Re: Docket 50-155, DPR-6 ZEK
Additional Information
for Proposed Tech Spec
Change No. 19

ADDITIONAL INFORMATION
Change No. 19
Consumers Power Company
Request for Change to the Technical Specifications
License No. DPR-6

EFFECT OF BETA CHANGES ON REACTIVITY ACCIDENT

BRP 2.1% Rod Drop

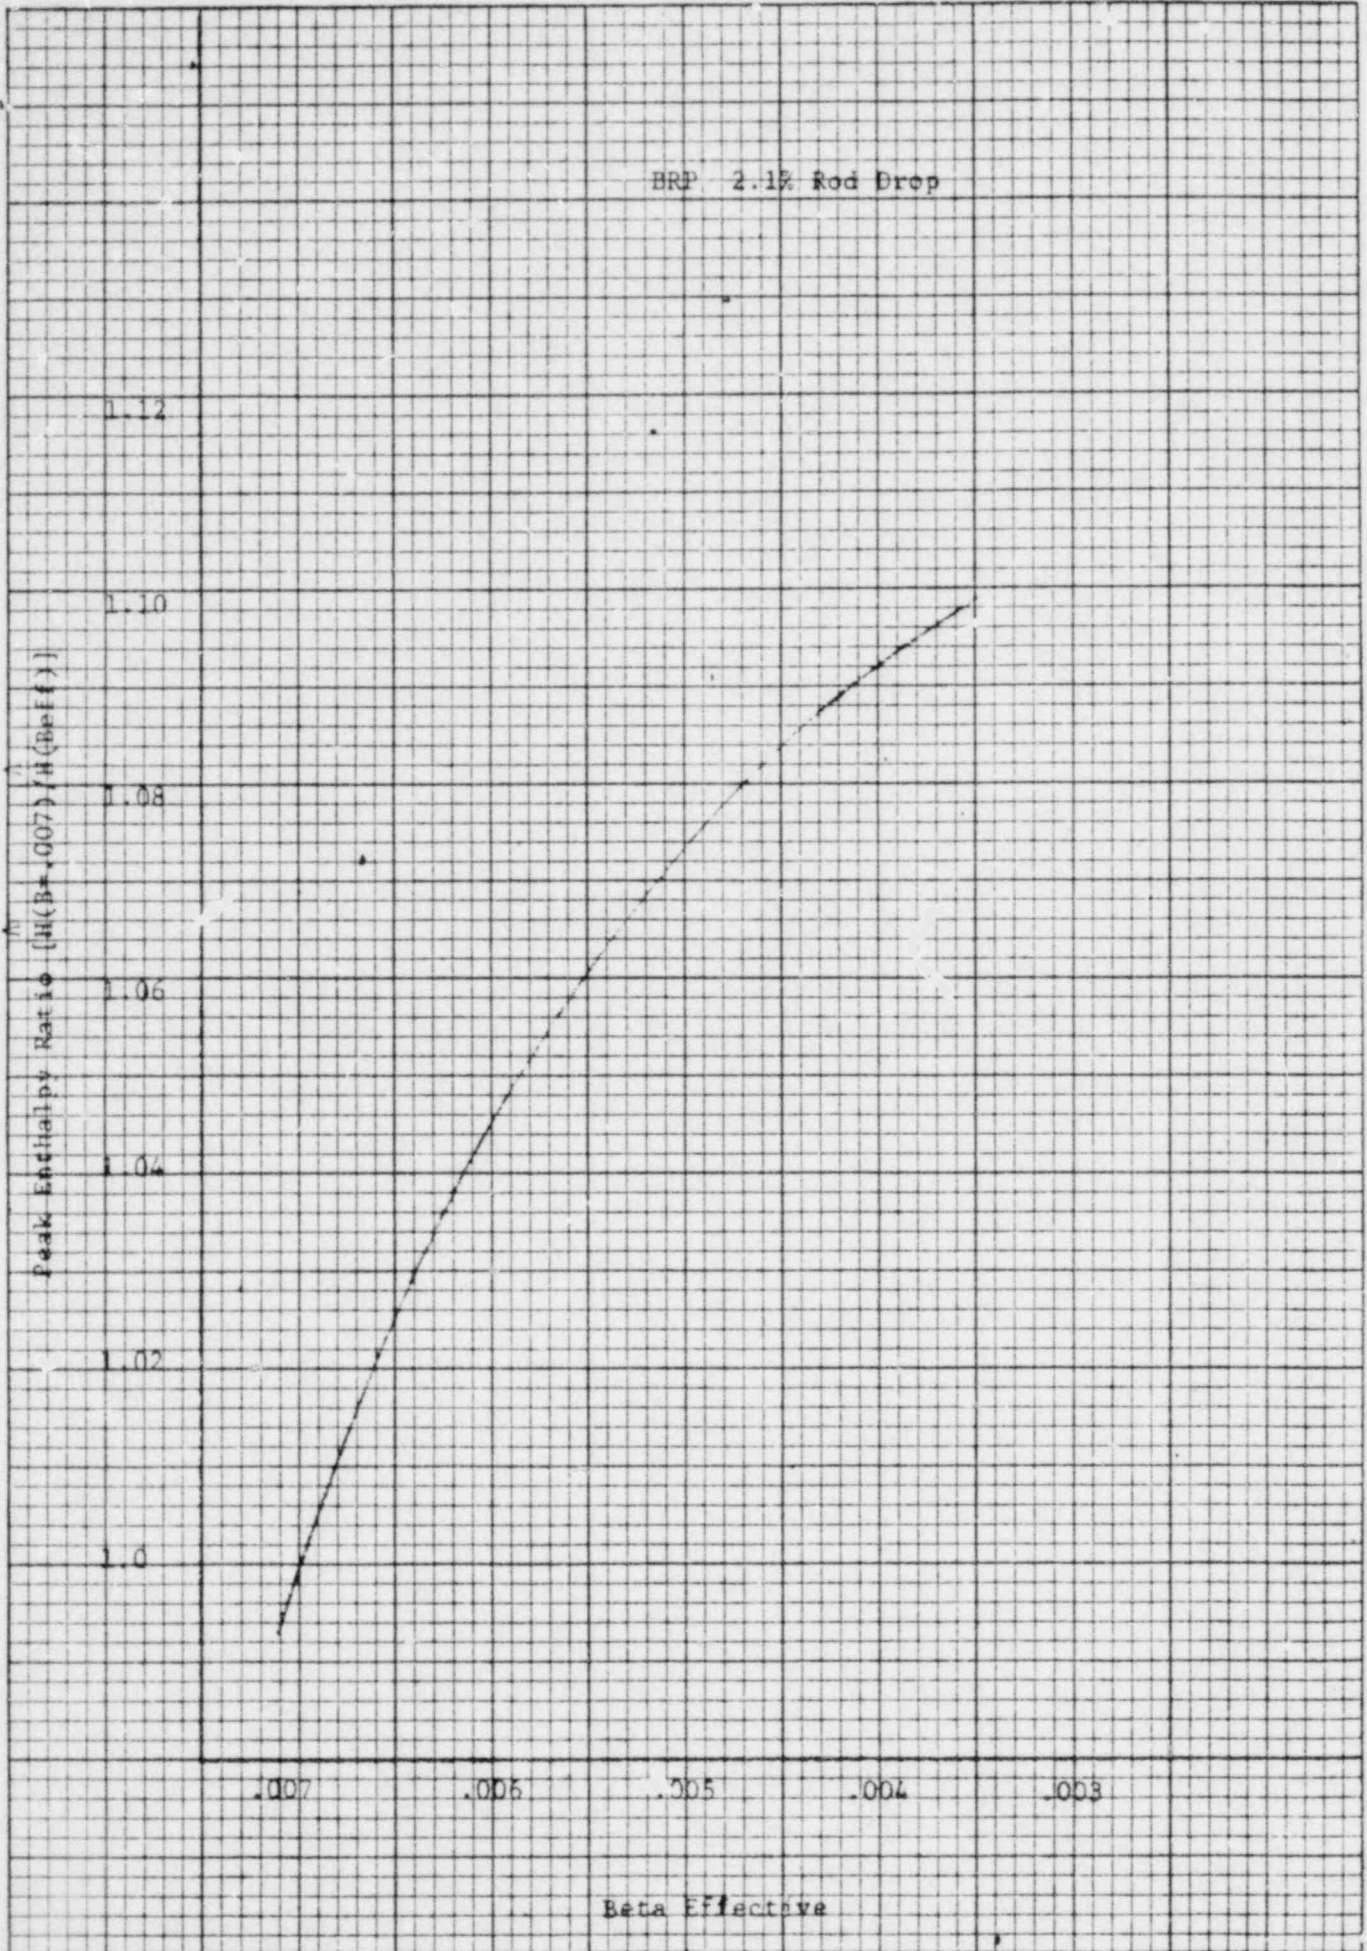
The reduced $\bar{\beta}_{\text{eff}}$ has the effect of reducing the period for a given Δk inserted into the reactor. The relative enthalpy rise in a rod drop accident as a function of $\bar{\beta}_{\text{eff}}$ is shown in the attached figure. From this it can be seen that the effect of changing β_{eff} from uranium at .605% to three clustered Pu assemblies at .55% is about 1.3%. If one made the artificial assumption that β were that of the plutonium assemblies (.385%) the enthalpy increase would be about 5%. These results were calculated for same conditions used to calculate the accident in previous analyses.
